Parlin Memorial Library

City of Everett ADA Transition Plan

July 2018

Institute for Human Centered Design

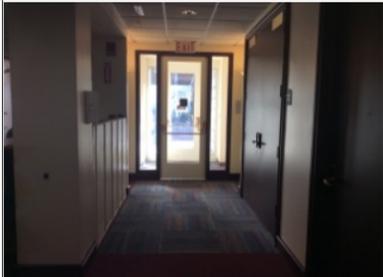
- The heater alongside the toilet in the girl's toilet room may pose a safety issue to people transferring to the toilet. Consider relocating heater for this reason and because it obstructs the proper location of the toilet paper.
